UNITED STATES PATENT AND TRADEMARK OFFICE

APPLICATION NO.	FILING DATE	FIRST NAMED INVENTOR	ATTORNEY DOCKET NO.	CONFIRMATION NO.
10/618,040	07/11/2003	Eiji Itoi	SOHMEI.PT1006	4117

Office Action Summary

DETAILED ACTION

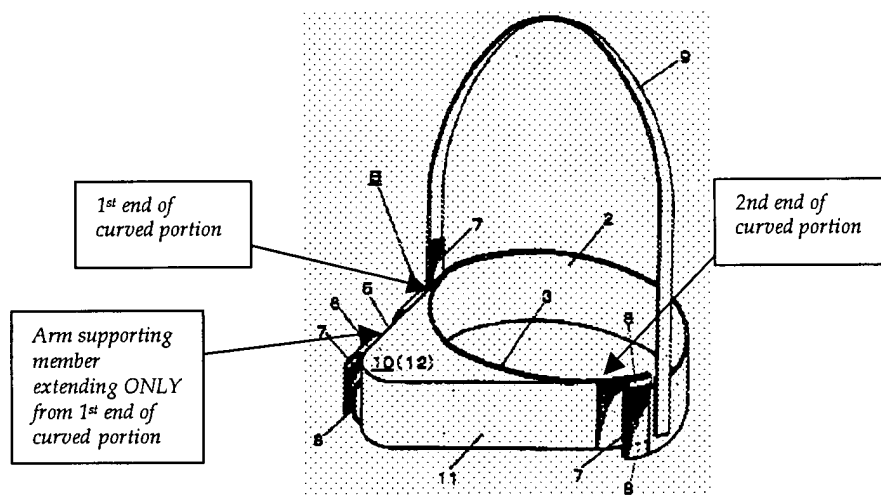
- On page 7 of the specification, Applicant states that the arm supporting side face (5) “is extended forward from both ends of the curved portion 3”. This appears to be contrary to the relevant drawings provided. See the marked up Figure below. The arm supporting side face extends forward from one end of the curved portion only. The arm supporting side face does not extend forward from the second end of the curved portion at all. It is unclear what this language, in light of the drawings, means.

- Also on page 7, the description of the arm supporting side face as extending forward from a “flank side”, with an inclined surface extending from “the other flank side”, is unclear. It is unclear to the examiner what “flank side” is referred to; whether it is a “flank side” of the user, a “flank side” of the device, or some other “flank side” altogether. Neither the specification nor the drawings provide any further clarification.

Correction is required.

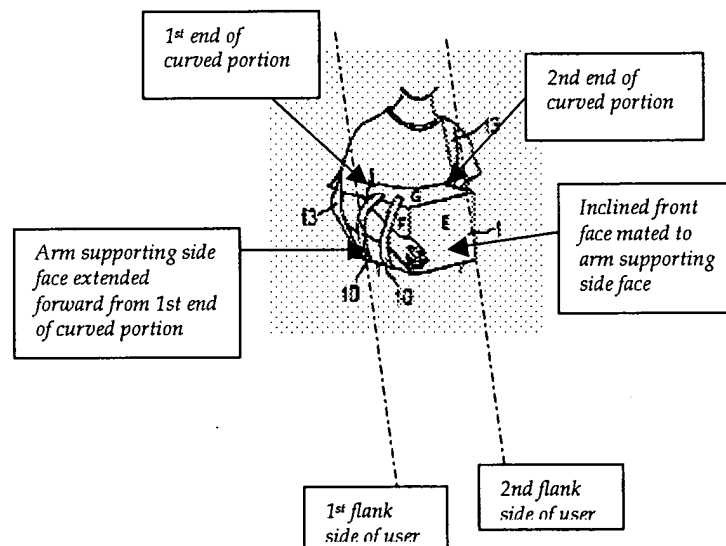
Tatsuya et al. disclose a shoulder dislocation acute-phase immobilization orthosis as shown in Figures 4a and 4b comprising:

a roughly triangular support block (1) formed of a lightweight hard synthetic resin material (such as styrene foam), with a width approximately greater than that of the forearm (see width of forearm versus width of support block in Figures 4a-b), comprising:

a curved portion (D) having two ends, which follows the shape of an abdominal part of a body;

an arm supporting side face (F) of approximately a forearm length (see length of forearm versus length of support block in Figures 4a-b), which is extended forward from a first

end of the curved portion to create an angle of inclination within an range of approximately 5° ~ 10° outward from at least one of a plurality of flank sides of the user, with respect to a surface extended forward in parallel with a flank side of the user, and an inclined front face (E) mated to said arm supporting side face from the other flank side of the user;

an arm supporting member (10) for immobilizing the forearm, provided on said arm supporting side face (F); and

a wrap-around belt (16) made of a flexible material, provided with a surface fastener (19/20) for fitting said support block (1) to the trunk part of a body. Applicant does not disclose any criticality to the width of the belt being that of the support block.

Therefore, it would have been obvious to have provided the belt disclosed by Tatsuya et al., with a width equal to that of the support block, or any other desired width, to achieve a secure fitting of the support block to the user.
